Te Tai o Poutini PLAN

To: Hearing Commissioners – Proposed Te Tai o Poutini Plan (pTTPP)

From: David Badham – Reporting Officer

Re: Reporting Officer Review of Response to Further Information Received under Minute 57 – Mining and Minerals Topic

Figure 1: Cascade Access Road. Source: AEE 14 November 2016

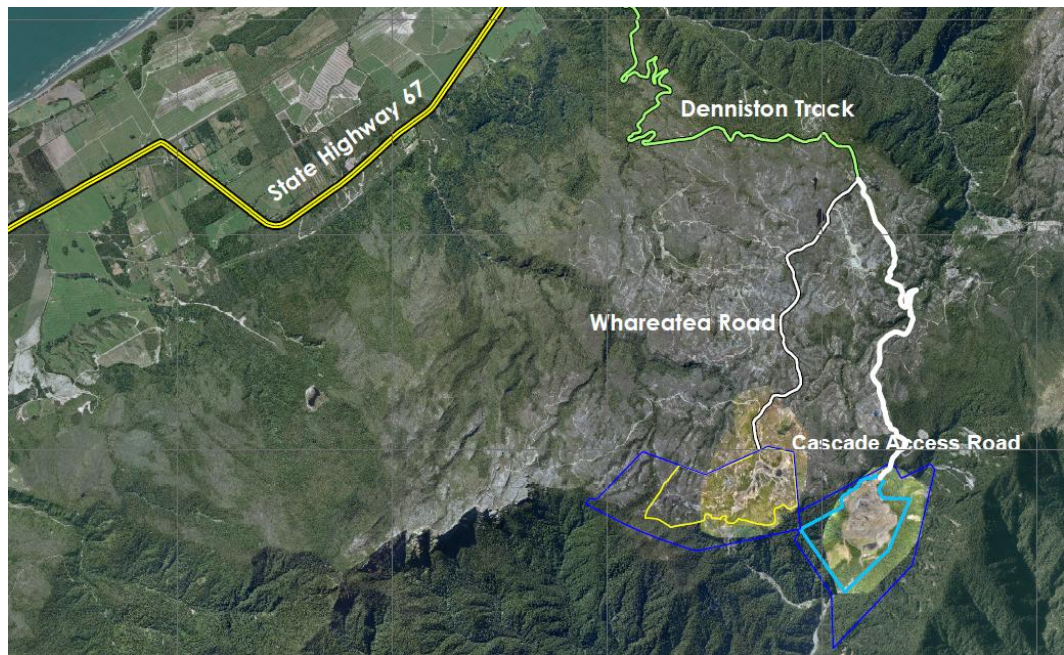
- (9) In response to Minute 57, further information was received from submitter Bathurst Resources Limited and BT Mining Limited (Bathurst). Whilst generally concurring with the majority of the recommendations concerning the Dennison Plateau, Bathurst seek the inclusion of established access roads to and from the Cascade Mine and Escarpment Mine and provided the following:

- (10) The AEE for Cascade Mine includes the “Escarpment Mine Location Map” dated 23 November 2015 which identifies Cascade Access Road. This access road is described as an existing access road which was created in 1941, prior to the requirement to obtain a Resource Consent. There was an easement with the Department of Conservation (DOC) for the use and maintenance of the road at the time of the resource AEE.

- (11) RC160055 was assessed as part of the Right of Reply and grants consent to undertake open cast coal mining, quarrying and processing of granite and associated activities. The conditions state the proposal will “proceed in accordance with the submitted application dated 14 November 2016 and the relevant plans”.

- (12) The Certificate of Compliance (CC12045) provides that the upgrading of Whareatea Mine Road in relation to the Escarpment Mine project is a permitted activity.
- (13) On the basis of the above, it is recommended that both of these access roads are included in the MINZ area for Denniston Plateau. An updated version of the Map of Authorised Mining Activities in relation to BCZ (Appendix 1a of the Right of Reply) is included at **Appendix 2**.
